UNITED STATES PATENT AND TRADEMARK OFFICE

10/602,054

Office Action Summary	Application No. 10/602,054	Applicant(s) CHOO ET AL.	
	Examiner TIMOTHY RUDE	Art Unit 2871

DETAILED ACTION

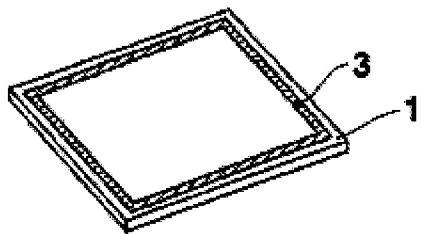
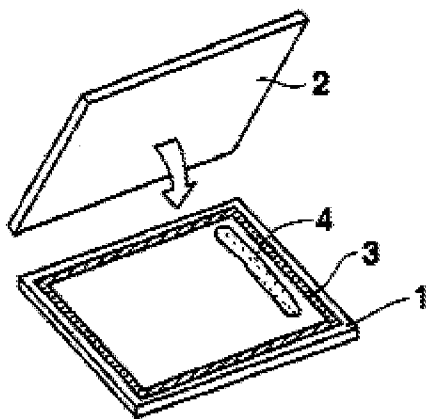
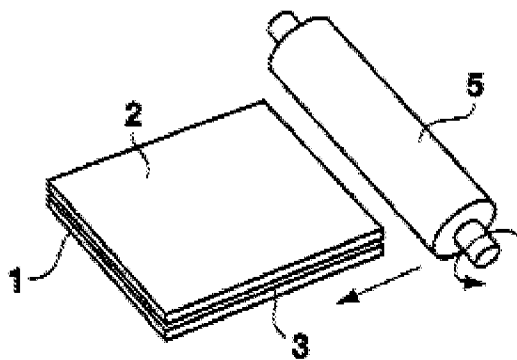
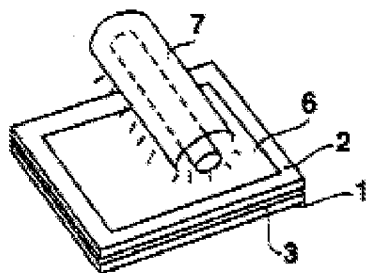
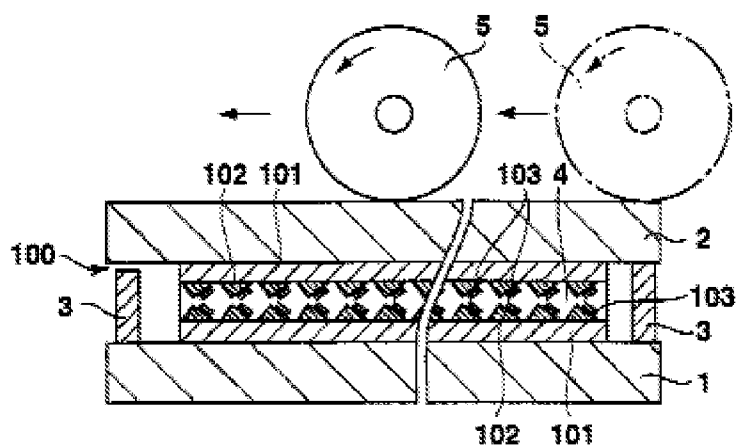
As to claim 57, Kawasumi discloses (Figures 1A-3B) apparatus and a method [system or apparatus] for manufacturing liquid crystal displays (entire patent, background of the invention, and especially col. 5, line 13 through col. 7, line 14), comprising: applying sealant on one of two substrates of a mother glass, the mother glass having at least one liquid crystal cell (col. 5, lines 14-37) [inherently requires Applicant's sealant applying unit, even if it is manual], a substrate-attaching unit, 5 and 7, conjoining substrates in a vacuum (background, suitable though more costly method – affords better degasification of liquid crystal material). Please note numerous references teach these steps/apparatus.

Kawasumi does not explicitly disclose the use of first loading unit and an in-line conveying unit.

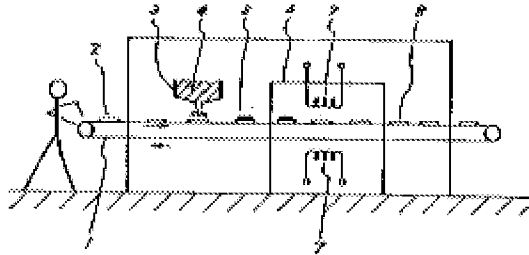
Adachi teaches the use of a first loading unit [at left in illustration] and a belt conveyor to provide a cleaner environment for the operators.

Adachi is evidence that ordinary workers in the art of liquid crystals would find the reason, suggestion, or motivation to add the use of a first loading unit and a belt conveyor to provide a cleaner environment for the operators.

Therefore, it would have been obvious to one having ordinary skill in the art of liquid crystals at the time the invention was made to modify the LCD system of Kawasumi with the first loading unit and a belt conveyor of Adachi to provide a cleaner environment for the operators.
